INTERIM
HUD/SOUTH DAKOTA RADIATION
SURVEY PROTOCOL

MacLaren Engineers		SILVER KING MINES, INC.	
TVA PROJECT		ESPEL MOUNT MILL DECOMMISSIONING	
APPROVED: 1/1/18		DATE: 01/11/18	
RESTORATION PLAN		18

3. Concerns receiving special attention are listed in detail in Sect. 1.5, "Results of the Scoping Process." These concerns include staff, public, and individual issues for which analysis and assessment were necessary. The major categories of concern were that

Fig. 2.2. Details of proposed Edgemont disposal site tailings impoundment area. Source: adapted from ER, rev. 3, Fig. 3.3-1.

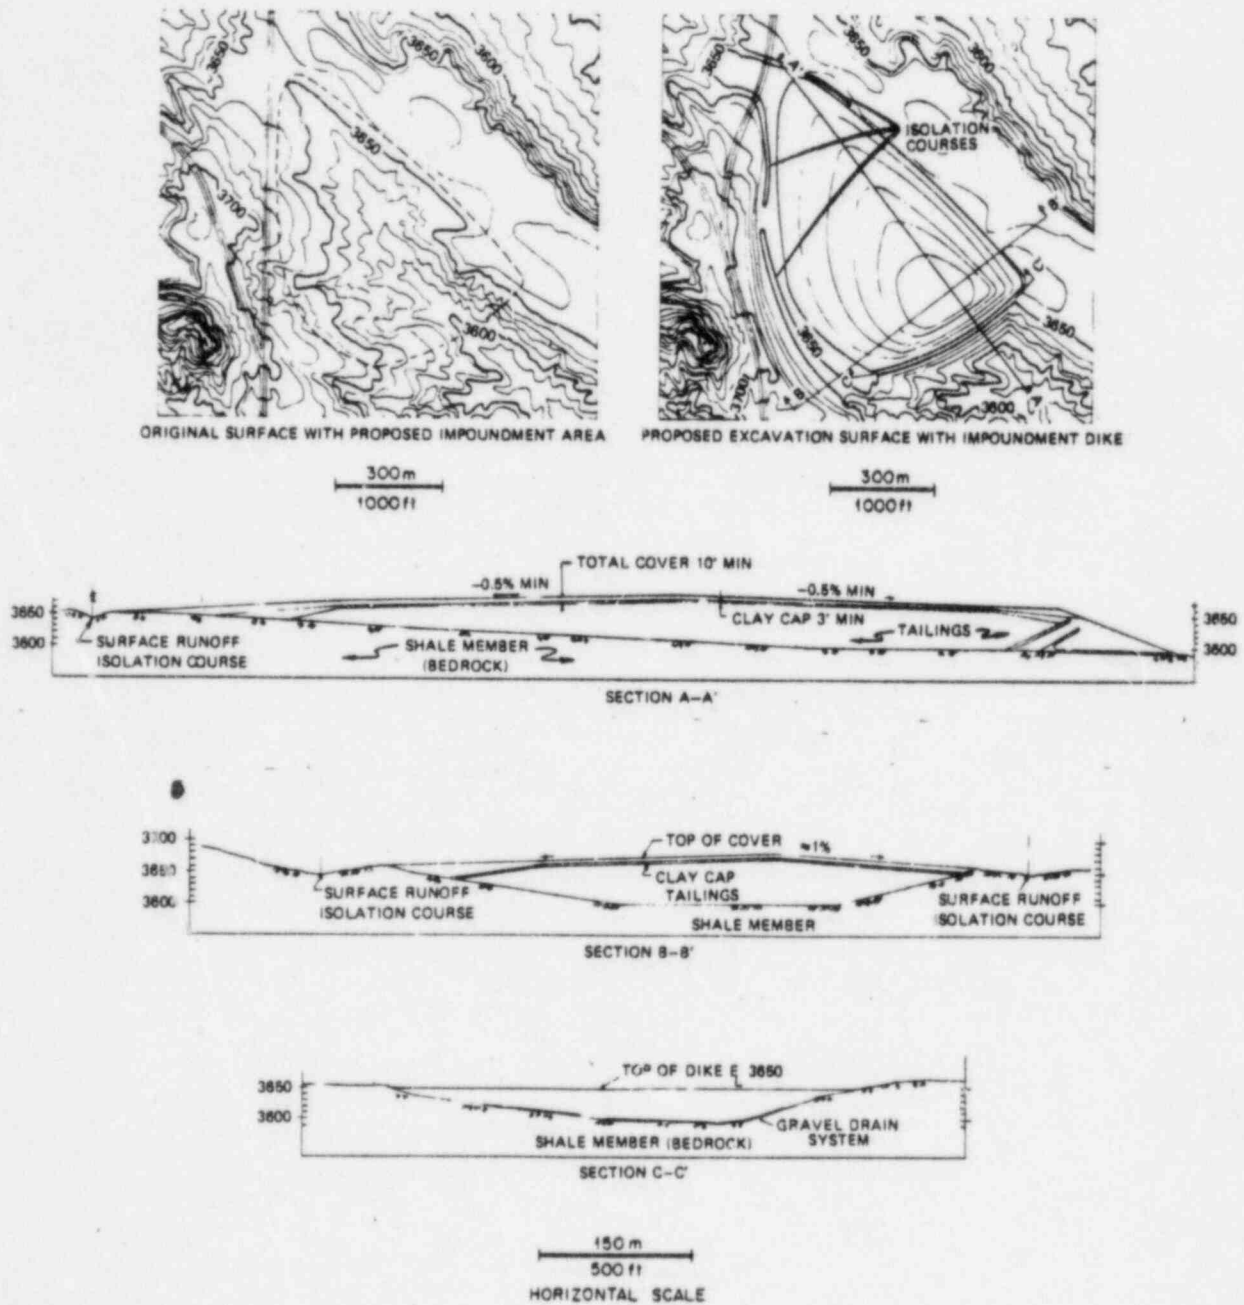
- a. The staff considers the proposed tailings disposal site (alternative C1) to be adequately remote from people.
- b. The proposed tailings disposal site and impoundment cover design provide adequate long-term protection from wind erosion.

If a clay liner is required, the applicant will define foundation requirements, determine whether subdrains and filters are needed, and establish criteria for clay emplacement and submit detailed emplacement plans to the NRC for approval.

Fig. 2.13. Cottonwood Creek temporary diversion. Source: ER, rev. 1, Fig. 3.5-3.

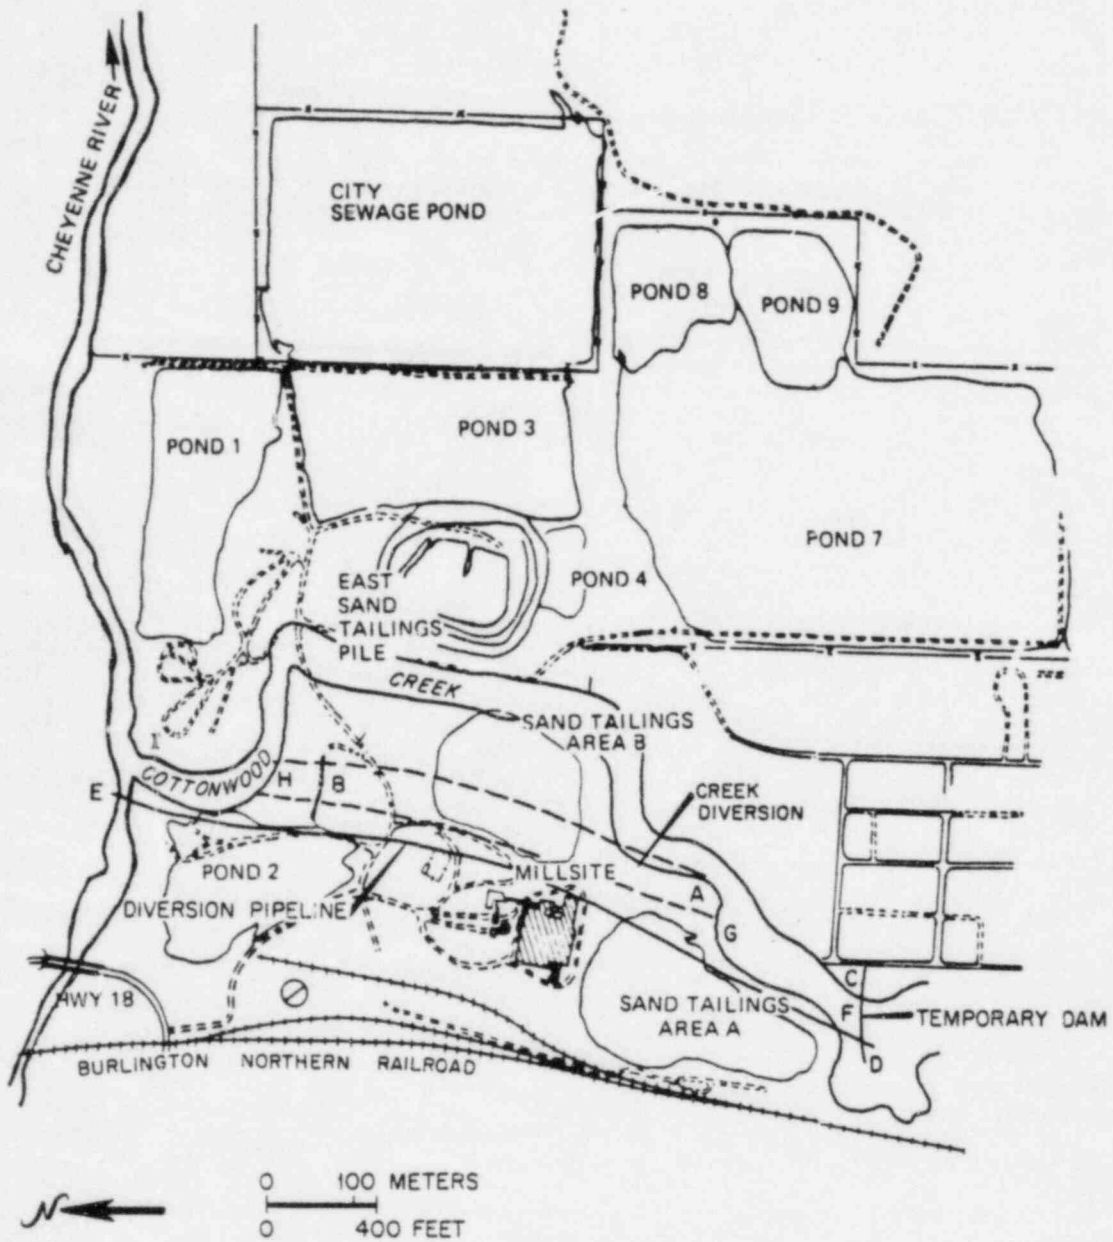
The applicant has proposed a temporary diversion of Cottonwood Creek (Fig. 2.13) so that the existing stream channel can essentially be dredged out and eventually a new channel can be constructed. The staff concurs with this plan, contingent upon confirmation that the contamination of the creek bed is widespread, as is currently anticipated.
